3GPP TSG CN Plenary Meeting #22
10th – 12th December 2003 Maui, USA.

NP-030498

Source: TSG CN WG4
Title: Corrections on Location Services
Agenda item: 7.4
Document for: APPROVAL

Spec	CR	Rev	Doc-2nd-Level	Phase	Subject	Cat	Ver_C
29.010	093		N4-031164	Rel-4	Wrong message appears in message flow	F	4.6.0
29.010	094		N4-031165	Rel-5	Wrong message appears in message flow	A	5.4.0
29.010	095		N4-031166	Rel-6	Wrong message appears in message flow	A	6.0.0

Figure 68b: Signalling for the request of Assistance Data or De-ciphering Keys

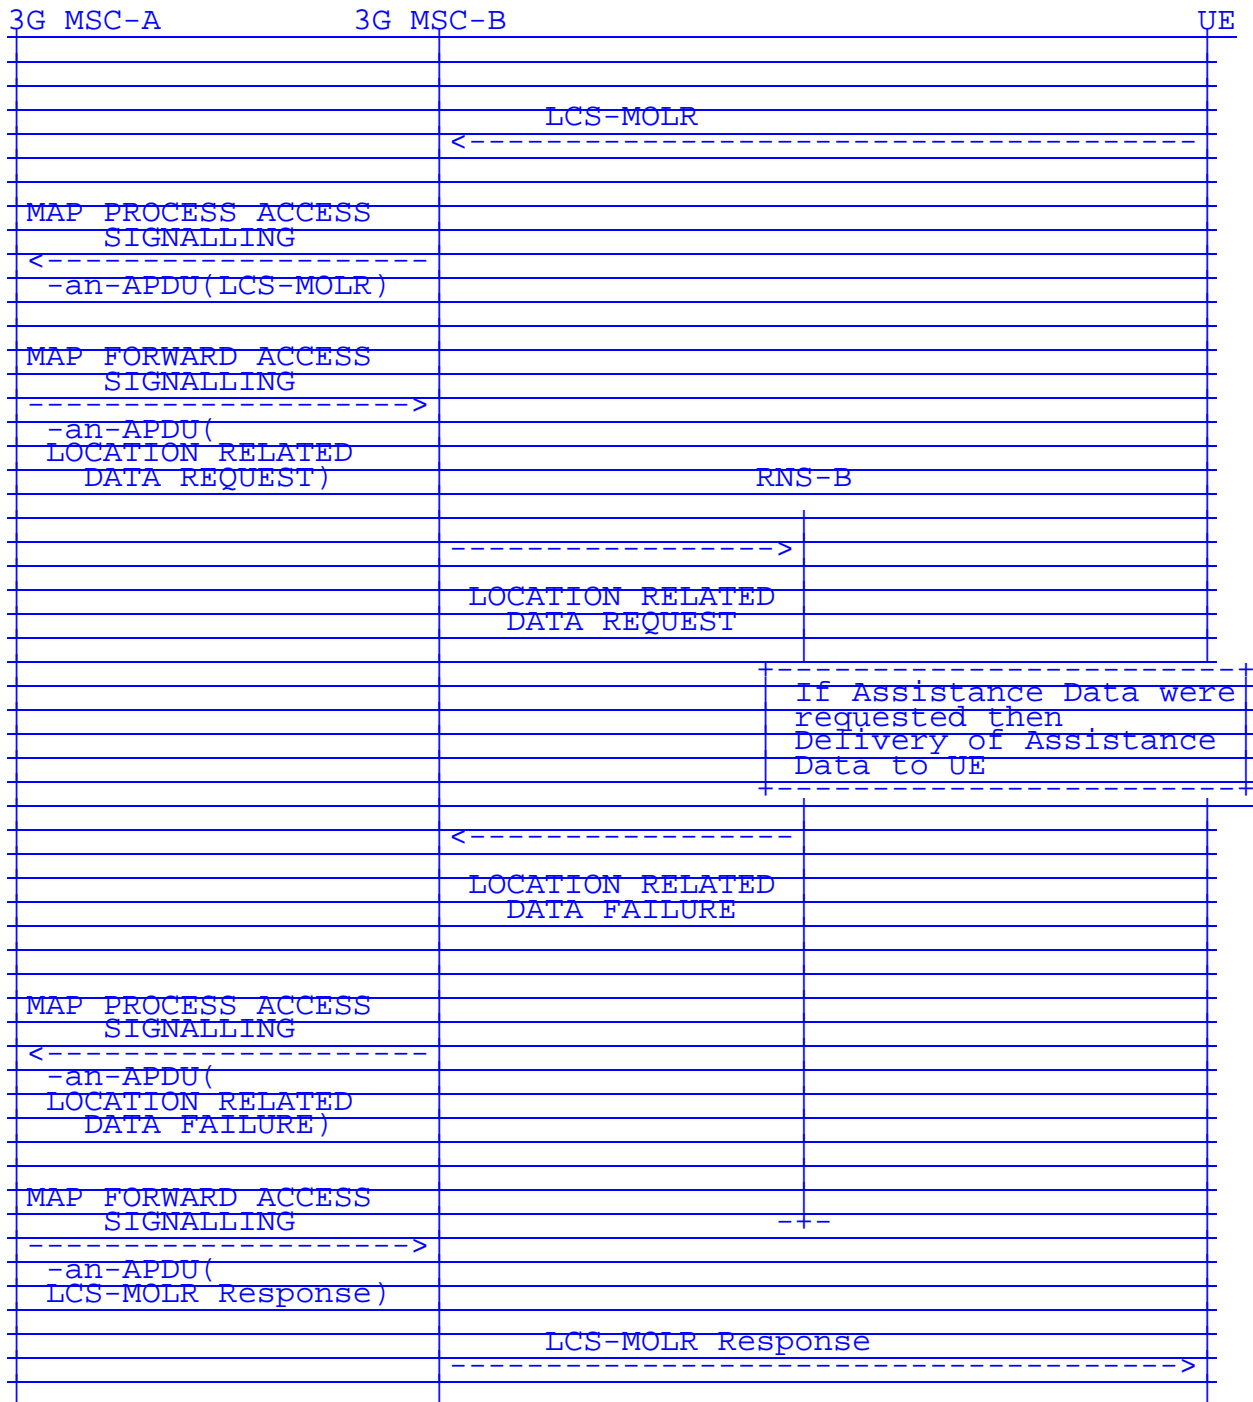
Reason for change:	⌘ This is an essential correction. In the second paragraph of clause 4.9.5.4 is mentioned that: If the request fails, either because the RNS-B cannot return the requested Deciphering Keys to the anchor 3G MSC or RNS-B cannot deliver the required Assistance Data to the MS, the signalling is the same as for the successful case and is shown in figure 67d. This is wrong. According to 3GPP TS 25.413 clause 8.31.3, the received RANAP message in case of positioning failure is LOCATION RELATED DATA FAILURE and not LOCATION RELATED DATA RESPONSE.
Summary of change:	⌘ Revise the text and add a figure to describe the correct signalling sequence. Renummer figure captions.
Consequences if not approved:	⌘ -Misalignment between 3GPP TSs 29.010 and 25.413. -Confused implementors possibly resulting in faulty implementation.

If the request fails, either because the RNS-B cannot return the requested De-ciphering Keys to the anchor 3G MSC or RNS-B cannot deliver the required Assistance Data to the MS, the signalling is ~~the same as for the successful case and is~~ shown in figure [68b7d](#).

Figure 68cb: Signalling for the request of Assistance Data or De-ciphering Keys

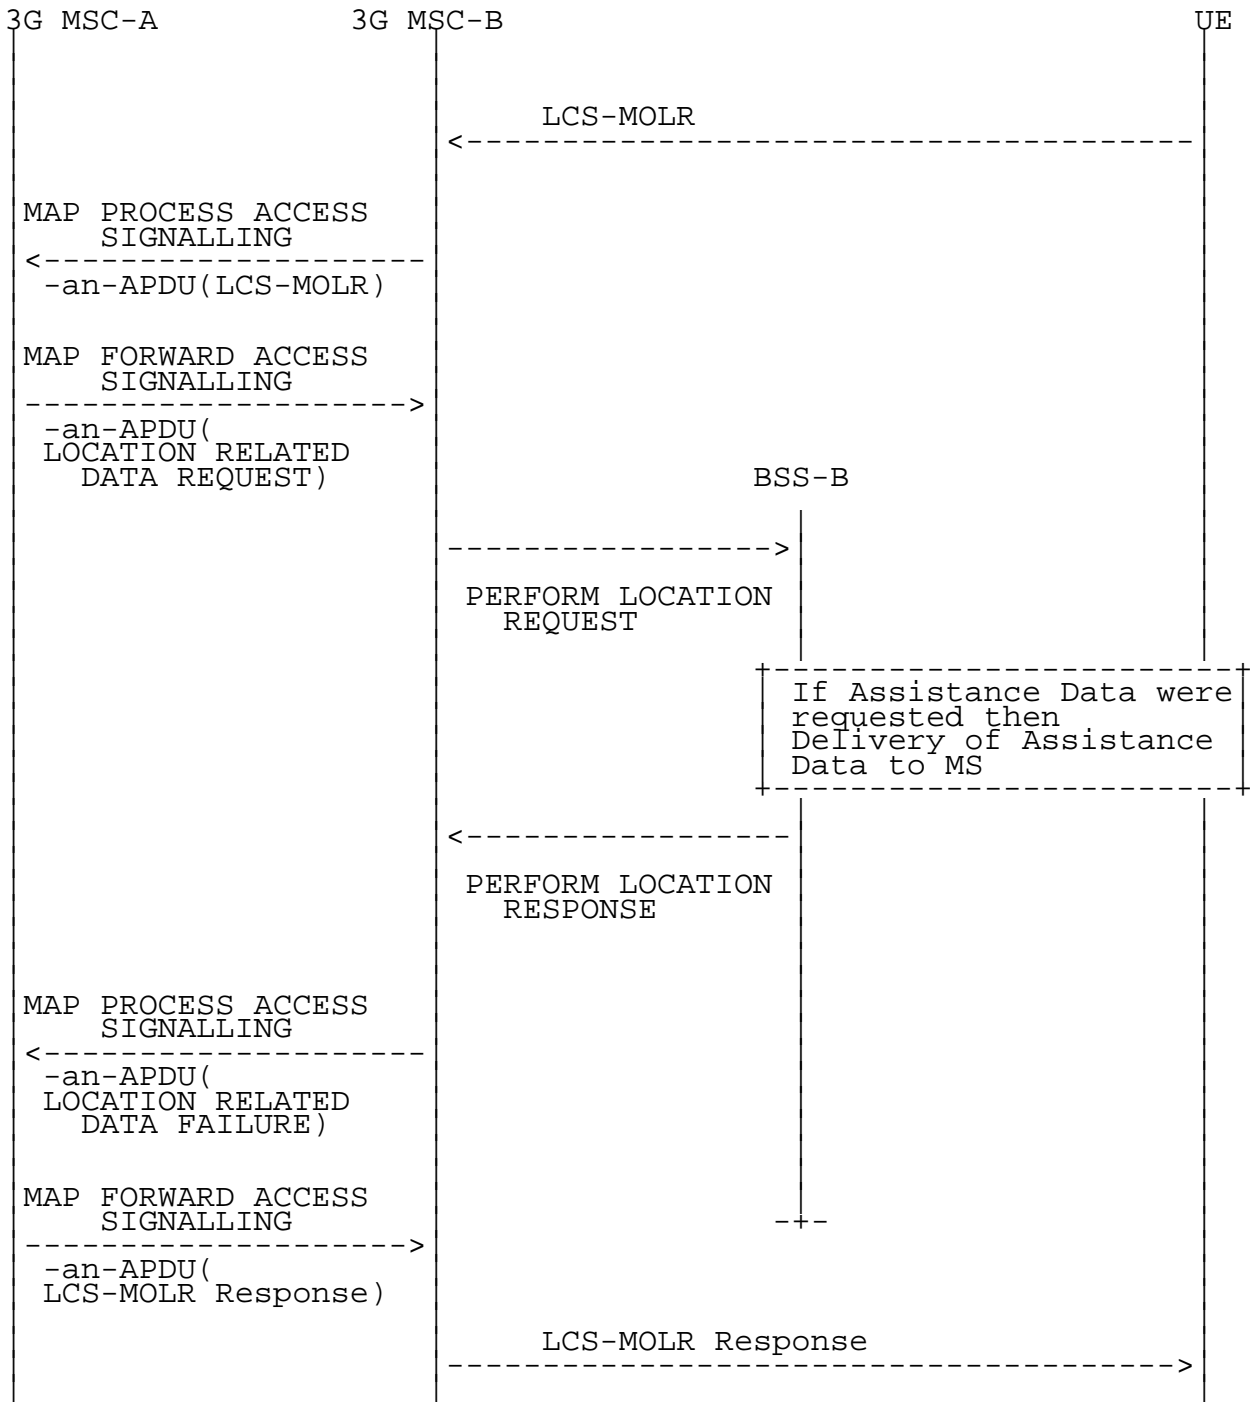
If the request fails, either because the BSS-B cannot return the requested De-ciphering Keys to the anchor 3G MSC or BSS-B cannot deliver the required Assistance Data to the MS, the signalling is as shown in figure 68**cb**.

Figure 68b: Signalling for the request of Assistance Data or De-ciphering Keys

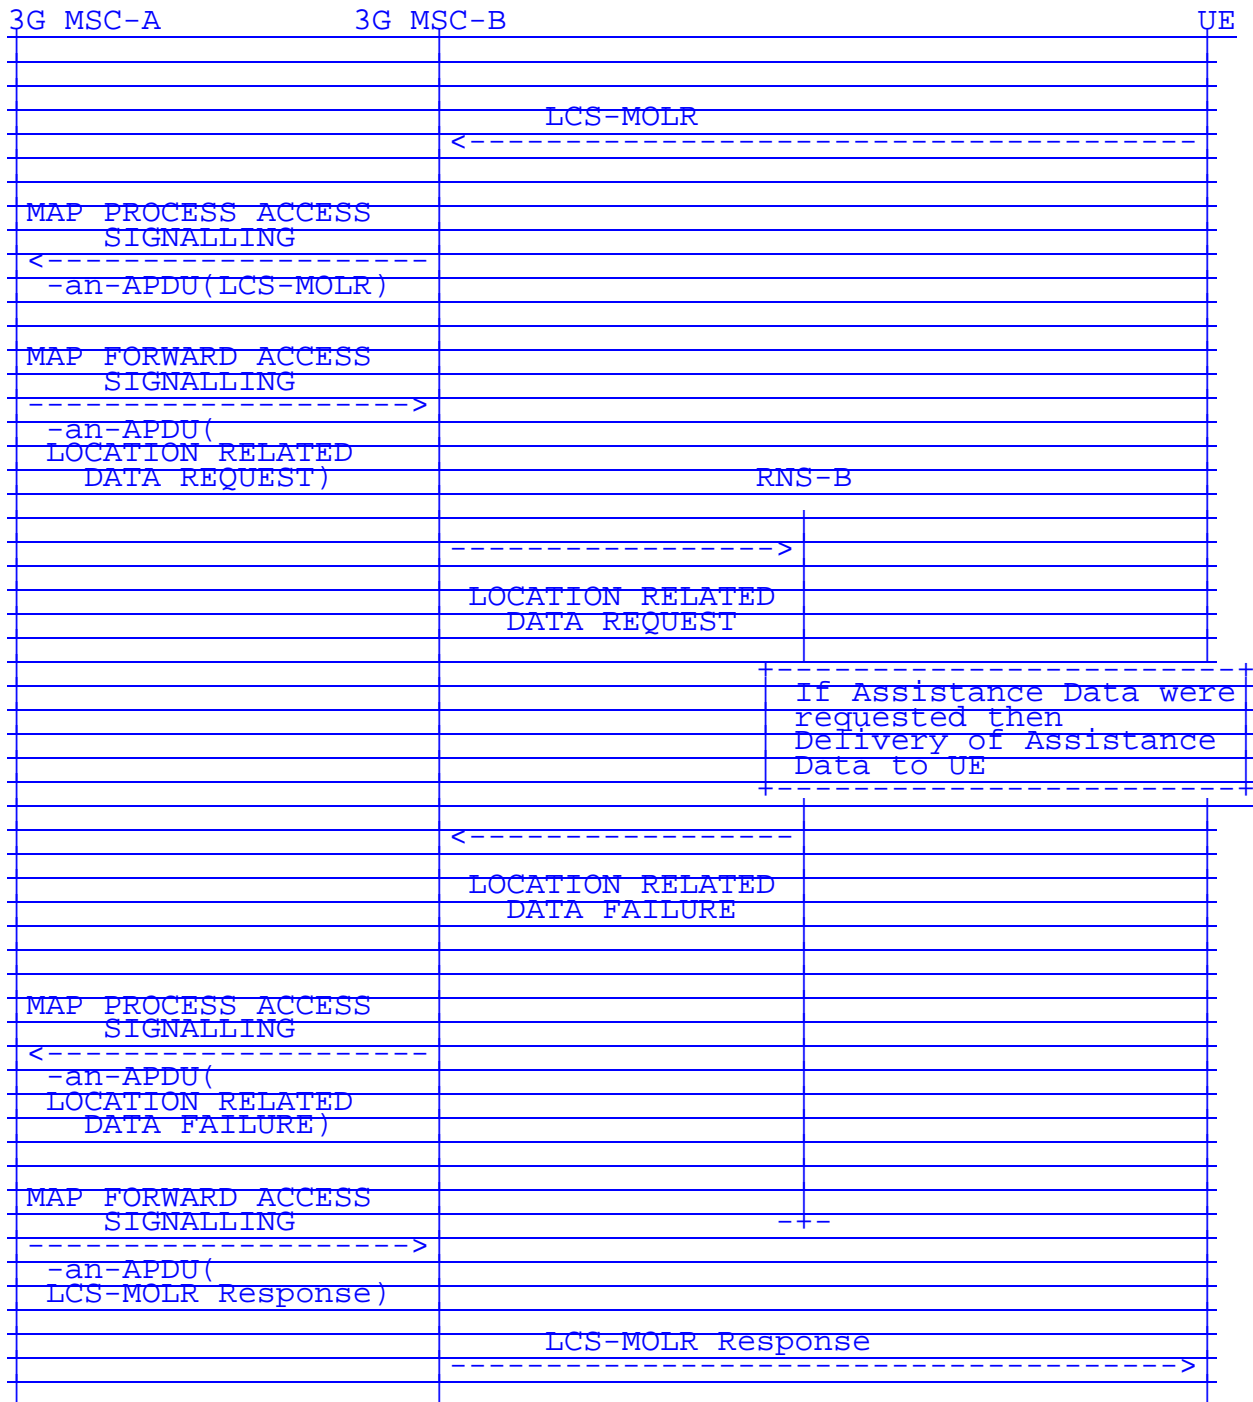
Reason for change:	⌘ In the second paragraph of clause 4.9.5.4 is mentioned that: If the request fails, either because the RNS-B cannot return the requested Deciphering Keys to the anchor 3G MSC or RNS-B cannot deliver the required Assistance Data to the MS, the signalling is the same as for the successful case and is shown in figure 67d. This is wrong. According to 3GPP TS 25.413 clause 8.31.3, the received RANAP message in case of positioning failure is LOCATION RELATED DATA FAILURE and not LOCATION RELATED DATA RESPONSE.
Summary of change:	⌘ Revise the text and add a figure to describe the correct signalling sequence. Renummer figure captions.
Consequences if not approved:	⌘ -Misalignment between 3GPP TSs 29.010 and 25.413. ⌘ -Confused implementors possibly resulting in faulty implementation.

If the request fails, either because the RNS-B cannot return the requested De-ciphering Keys to the anchor 3G MSC or RNS-B cannot deliver the required Assistance Data to the MS, the signalling is ~~the same as for the successful case and is~~ shown in figure ~~68b7d~~.

Figure 68cb: Signalling for the request of Assistance Data or De-ciphering Keys

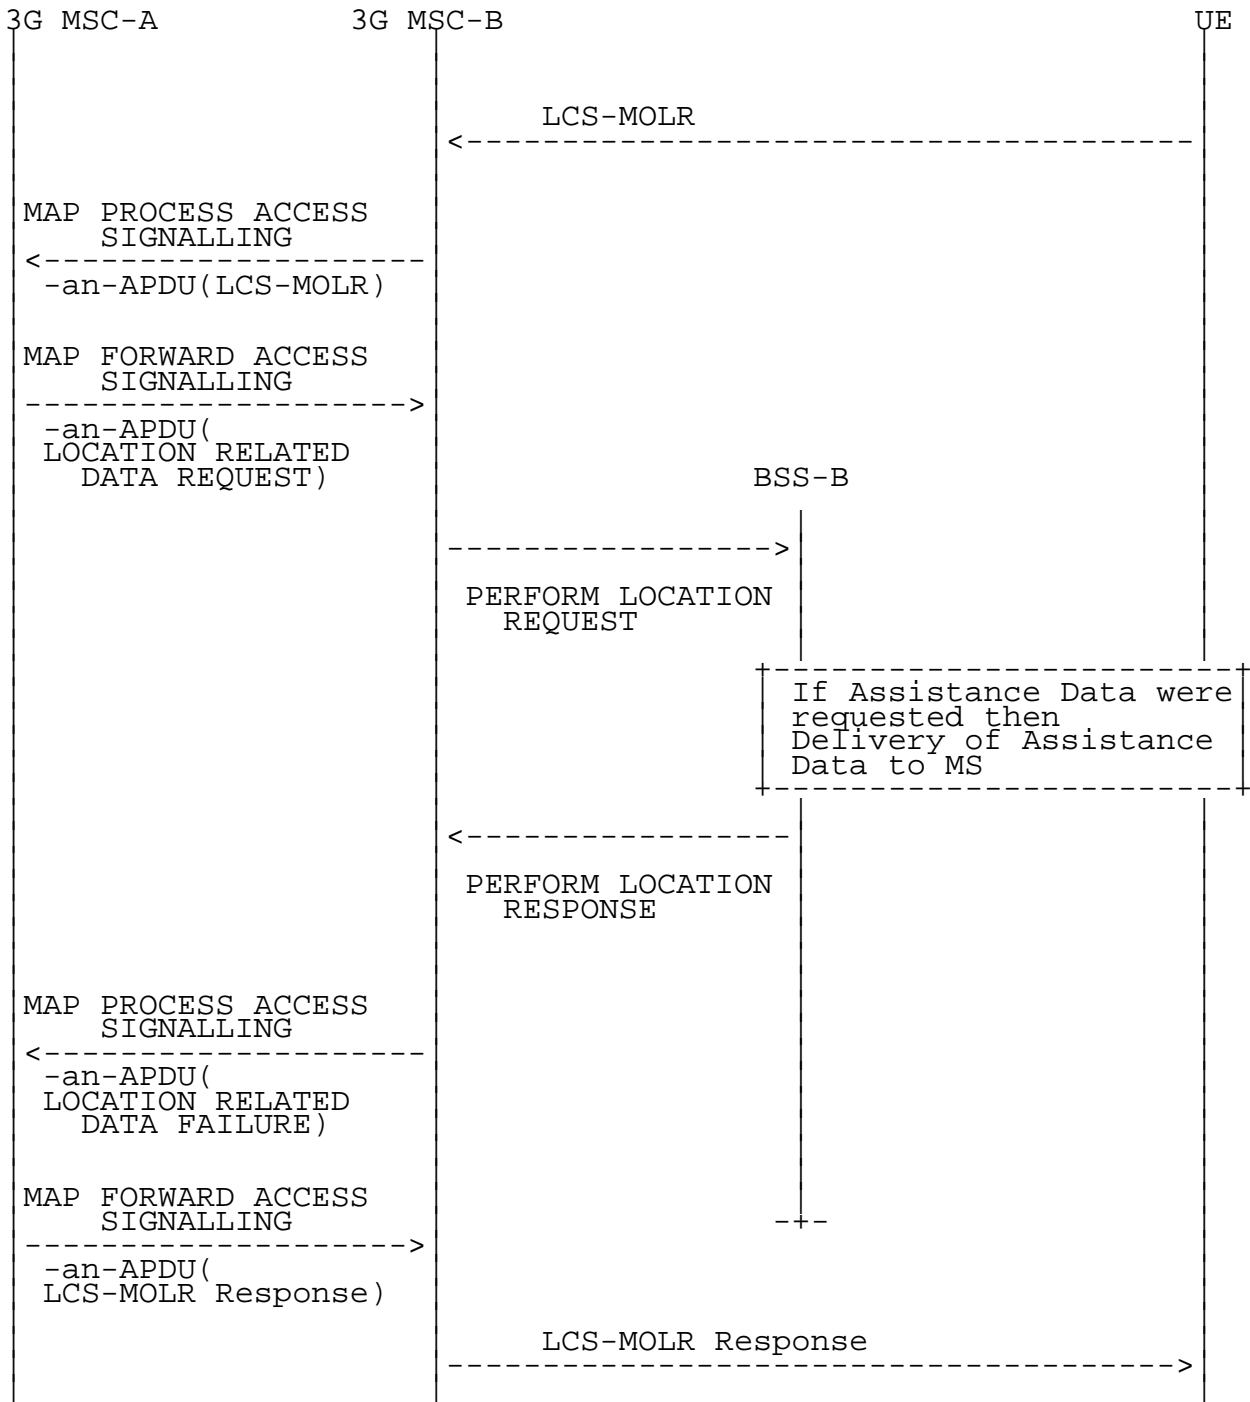
If the request fails, either because the BSS-B cannot return the requested De-ciphering Keys to the anchor 3G MSC or BSS-B cannot deliver the required Assistance Data to the MS, the signalling is as shown in figure 68**cb**.

Figure 68b: Signalling for the request of Assistance Data or De-ciphering Keys

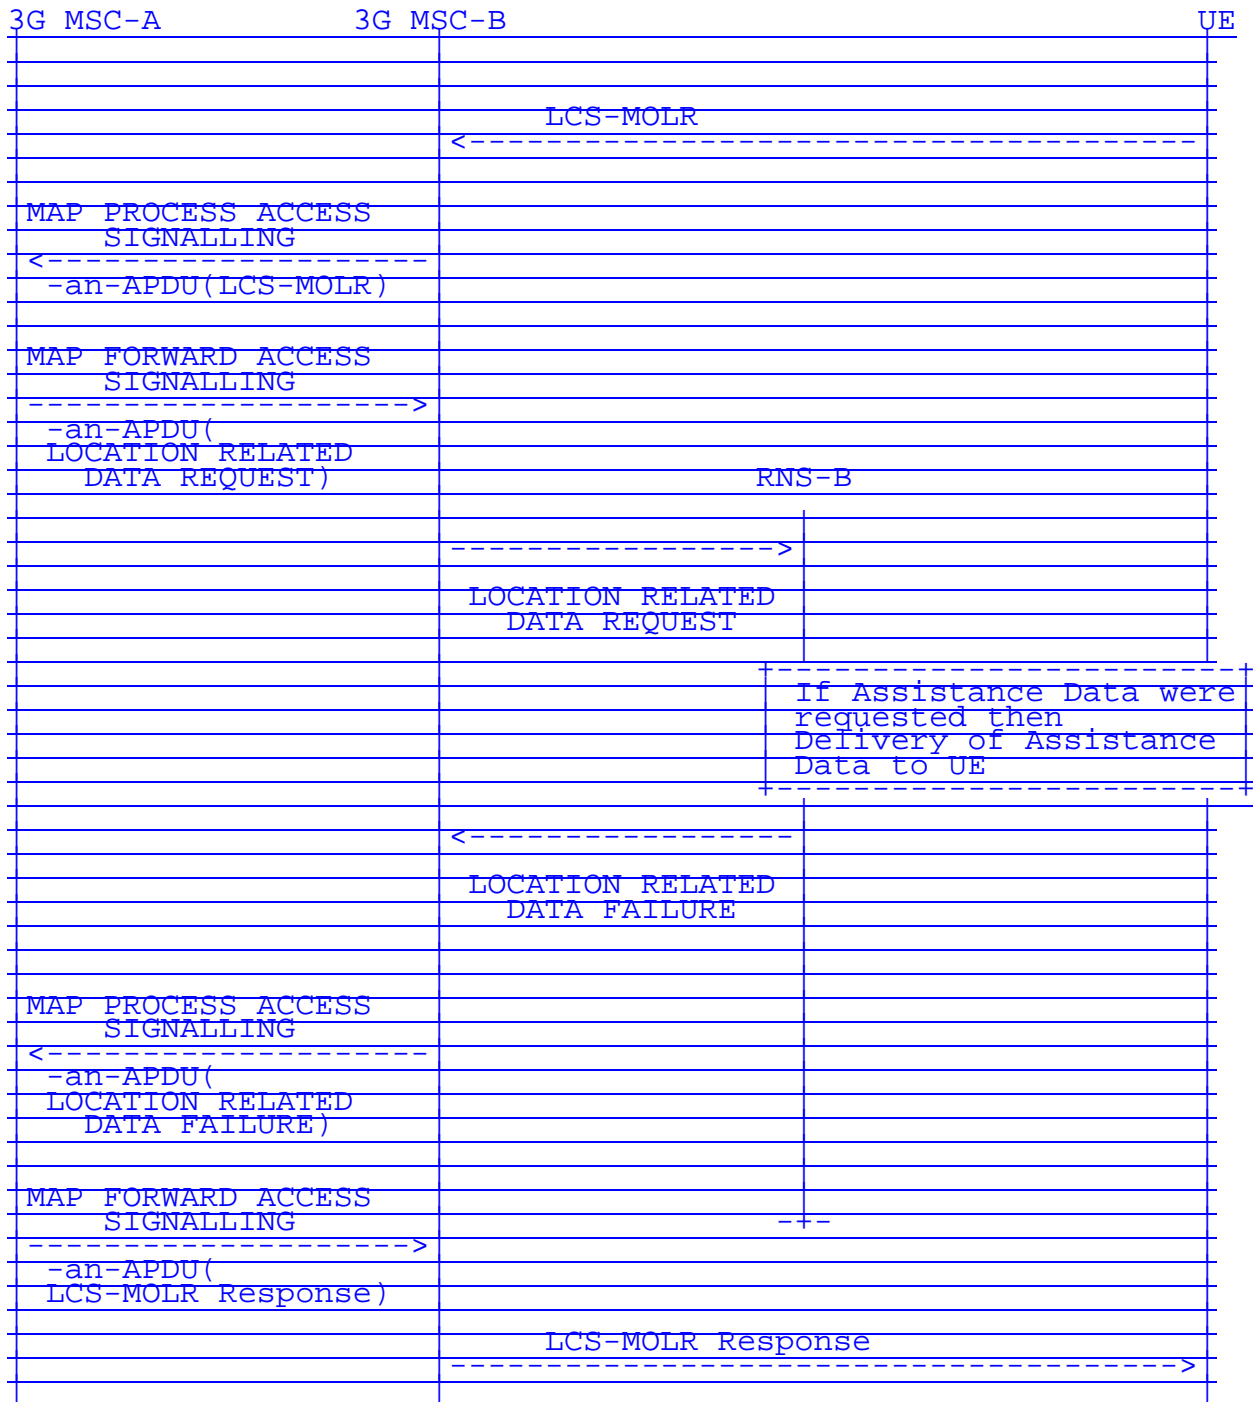
Reason for change:	⌘ In the second paragraph of clause 4.9.5.4 is mentioned that: If the request fails, either because the RNS-B cannot return the requested Deciphering Keys to the anchor 3G MSC or RNS-B cannot deliver the required Assistance Data to the MS, the signalling is the same as for the successful case and is shown in figure 67d. This is wrong. According to 3GPP TS 25.413 clause 8.31.3, the received RANAP message in case of positioning failure is LOCATION RELATED DATA FAILURE and not LOCATION RELATED DATA RESPONSE.
Summary of change:	⌘ Revise the text and add a figure to describe the correct signalling sequence. Renummer figure captions.
Consequences if not approved:	⌘ -Misalignment between 3GPP TSs 29.010 and 25.413. ⌘ -Confused implementors possibly resulting in faulty implementation.

If the request fails, either because the RNS-B cannot return the requested De-ciphering Keys to the anchor 3G MSC or RNS-B cannot deliver the required Assistance Data to the MS, the signalling is ~~the same as for the successful case and is~~ shown in figure ~~68b7d~~.
